TECHNICAL BULLETIN

No. 206L-07-223

MODEL AFFECTED: 206L SERIES

SUBJECT: MAIN ROTOR MAST NUT INSTALLATION
PROCEDURE, IMPROVEMENT OF

FIGURE 1: Mast Nut Paint Scheme (sheet 1)

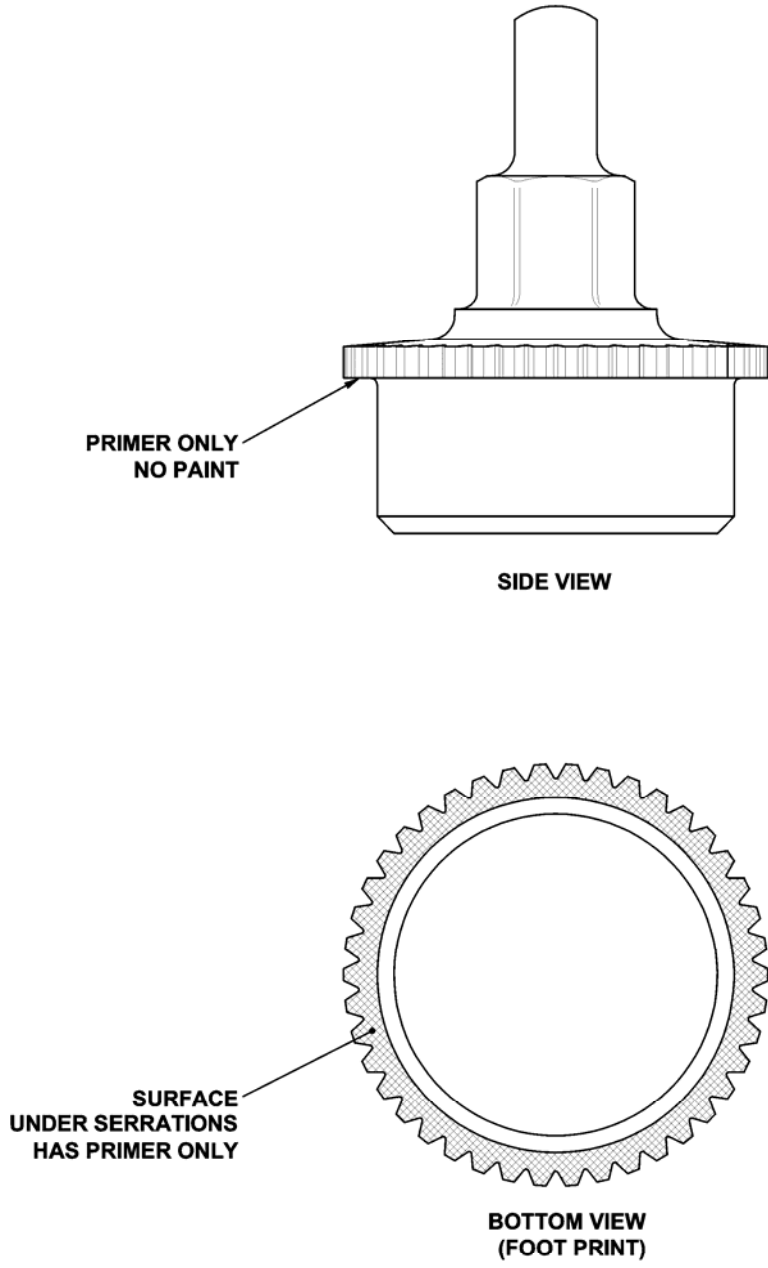
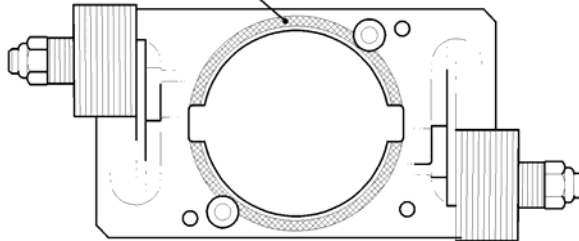
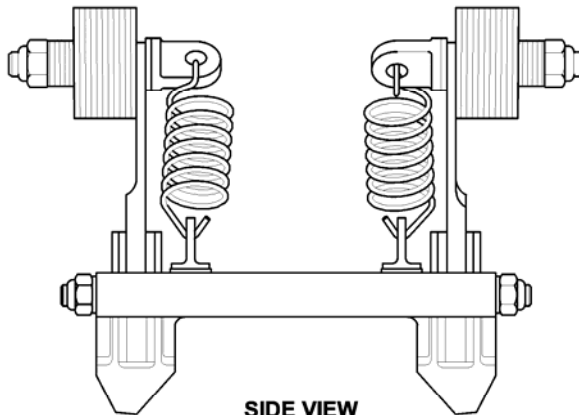
1. Ensure that the paint and primer are applied to the flap restraint support P/N 206-010-191, the trunnion P/N 206-011-120 and mast nut P/N 206-011-152 as per new paint scheme (Refer to Figure1, sheet 1, 2, 3). Failure to adhere to the paint scheme requirement may result in difficulties to stabilize the mast nut torque.
2. Install the flap restraint and mast nut as follows:
 - a. Apply a thin coat of unreduced polyamide epoxy primer (C-204) between the faying surfaces of the main rotor trunnion and the flap restraint support (Refer to Figure 2).

FIGURE 1: Flap Restraint Paint Scheme (sheet 2)

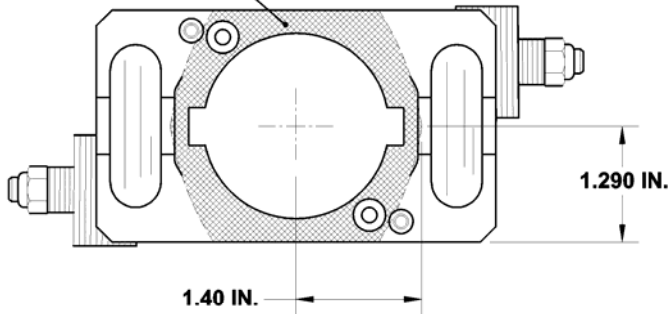
PRIMER ONLY ON SURFACE IN CONTACT
WITH MAST NUT FOOT PRINT

PRIMER ONLY ON SURFACE
IN CONTACT WITH TRUNNION

FIGURE 2: Main Rotor Installed

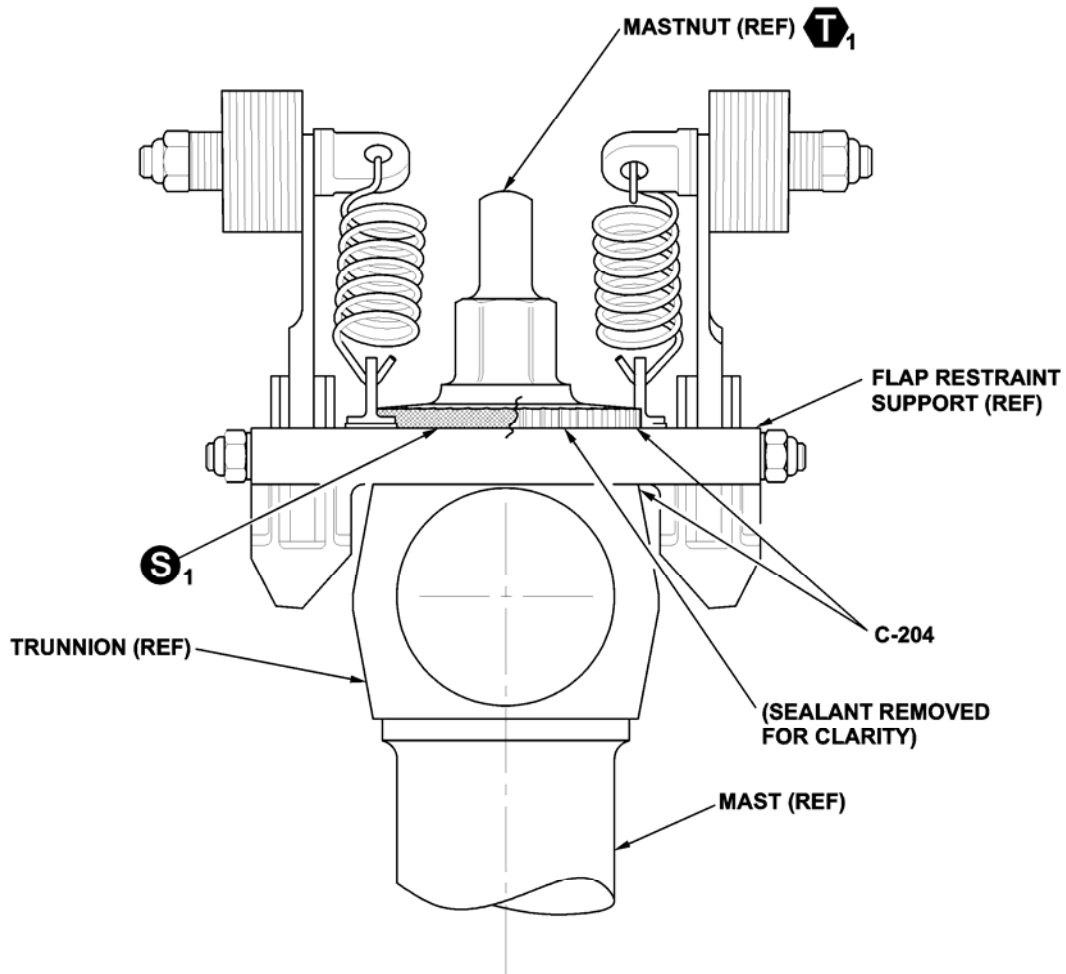
- c. Apply a bead of sealant MIL-PRF-81733, Type II (C-251) to the mating edge of the mast nut serrations and the flap restraint support (Refer to Figure 2). Ensure no sealant penetrates the mast nut lock retainer bolt hole. Make sure that the bead of sealant is smoothed out to avoid an area capable of retaining pooled moisture.

S₁ MIL-PRF-81733 TYPE II (C-251)

T₁ 250 TO 275 FT-LBS
(339 TO 373 Nm)
